SUNOCO PIPELINE
535 Fritztown Road
Stinking Spring, PA 19608

October 16, 2017

**Re: Wetland C-17 Crossing, Horizontal Directional Drill Location (S2-0075)
Hydrological Reevaluation Report
PADEP Permit No. E11-352
Cambria Township, Cambria County**

Proposed HDD S2-0075 Plan and Profile
Showing Position of Upper Freeport Coal

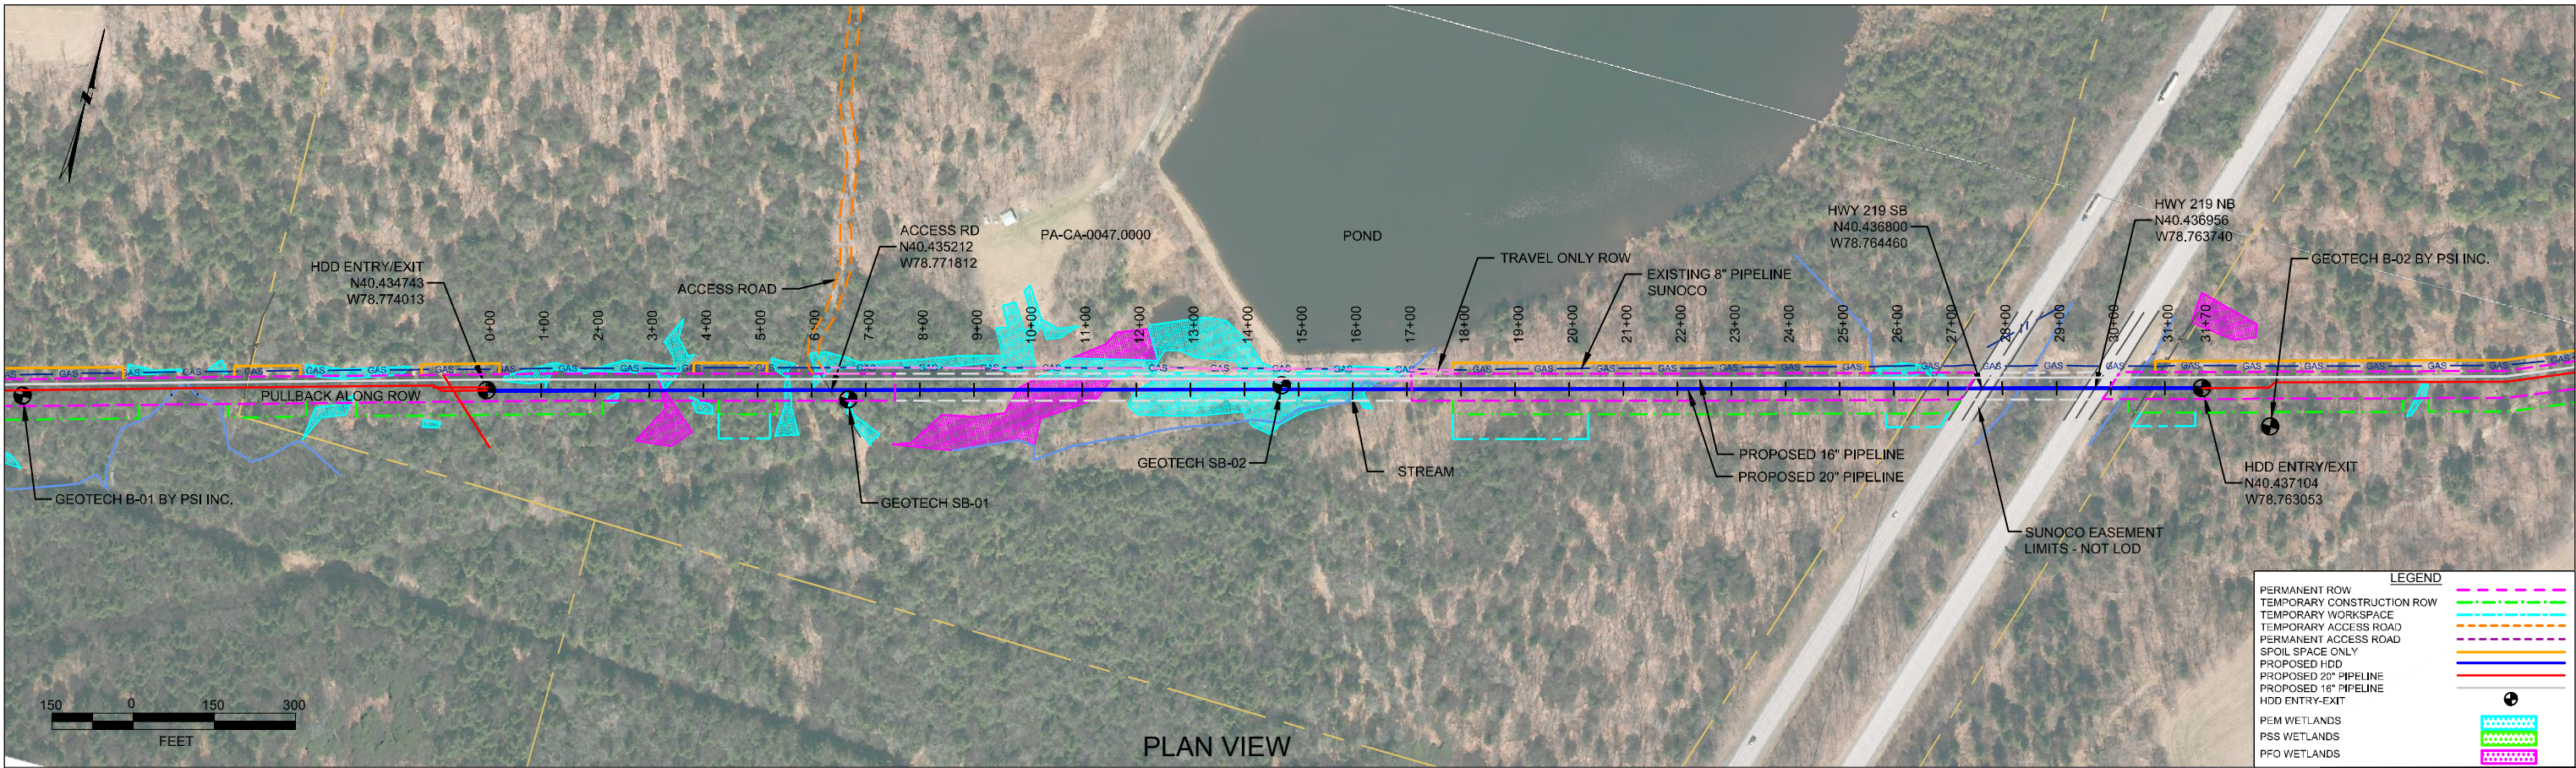
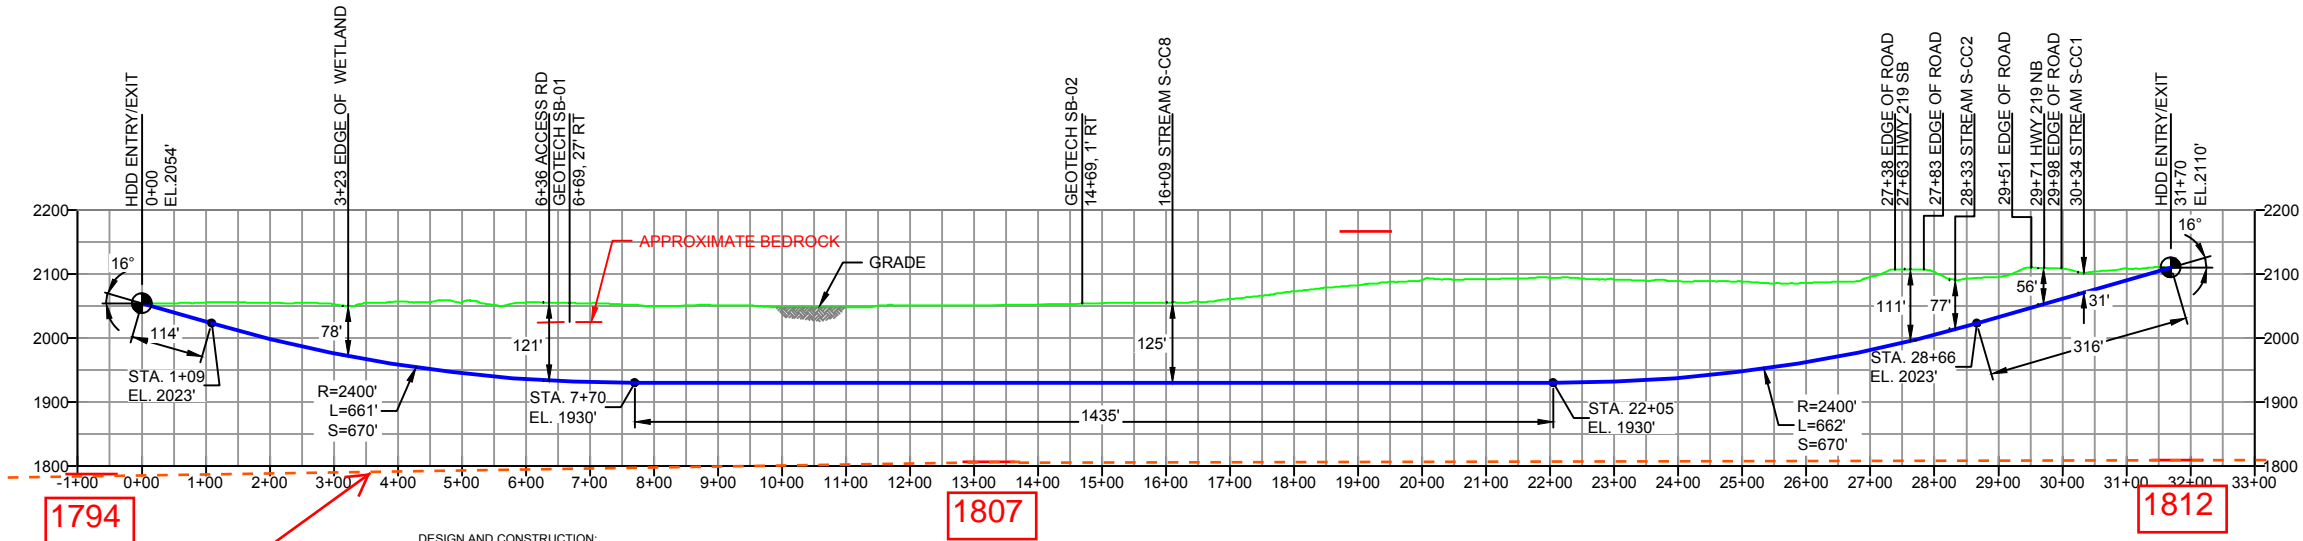
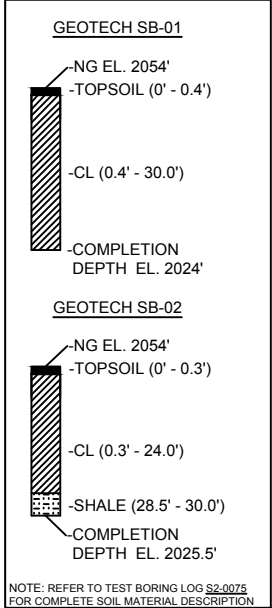
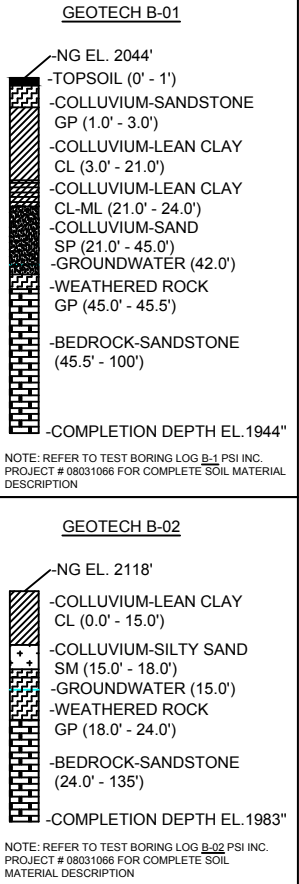
- 1. The underground mining information provided is not complete. An underground mine, Rosebud Coal Company's Madison Mine in the Upper Freeport Coal Seam exists near the alignment and should be considered and discussed. Potential subsidence effects to the HDD construction and future integrity of the pipeline should be considered and discussed.**

2. **While geotechnical borings have been provided, neither boring reaches the strata that will be penetrated by the majority of the length of the horizontal borings. Please provide geotechnical boring information for the strata that will be penetrated by the majority of the horizontal borings.**

SPLP contacted Rosebud Coal Company and obtained the currently permitted, and potential future, coal mining plans, and information on mine subsidence monitoring in the area of the Wetland C17 HDD. Attached is a technical report prepared by Groundwater and Environmental Services, Inc. (GES) that evaluates the potential effects of current and foreseeable mining operations on this section of the Mariner II pipeline installation. Based on that report, SPLP does not believe that current or potential future coal mining below the proposed pipeline alignment

will result in any potential material subsidence effects to the HDD construction or have any impact on future pipeline integrity.

Attached for your review are two geologic investigation cores obtained in near vicinity to the Wetland C17 HDD provided by Rosebud Coal Company. Notes have added to identify the depth of the HDD on these profiles. Core MAD 13-14 was obtained 450 foot south-southwest of the HDD's west exit point. Core MAD 15-016 was obtained 1,100 foot southeast of the HDD's east entry point. SPLP has not identified any geologic data on these cores that would induce a redesign of the HDD profiles as submitted.

Using the information shown on the test boring logs provided by Rosebud Mining (Attachment B) it is estimated that the top of the Upper Freeport coal seam is at approximate elevation 1812 ft amsl at the east entry/exit of the planned profile of S2-0075 and at approximate elevation 1794 ft amsl at the west entry/exit location (see Attachment C). The profile shows the deepest part of the pipe installations will be in the middle of the HDD profile at elevation 1930 ft amsl. Using the existing information it is estimated that the shortest distance between the top of the Upper Freeport coal and HDD profile will be approximately 120 feet at Station 22+00. Note, these estimates of Upper Freeport coal position are based on the surface of the top of the coal projected from information provided on the four boring logs provided by Rosebud Mining. Estimates of coal position elevation are dependent upon the surface elevations reported on the logs. According to Rosebud Mining the surface elevation for MAD 13-08, which is listed to the nearest hundredth of a foot, was supplied by a professional survey. The surface elevations for the three remaining logs (MAD 15-007, MAD 15-0016 and MAD 13-14) were taken off of topographic mapping obtained by Rosebud Mining and are accurate to +/- 5 feet. Taking this into consideration, a conservative estimate of the closest distance between the profile and the top of the Upper Freeport coal would be approximately 115 feet.
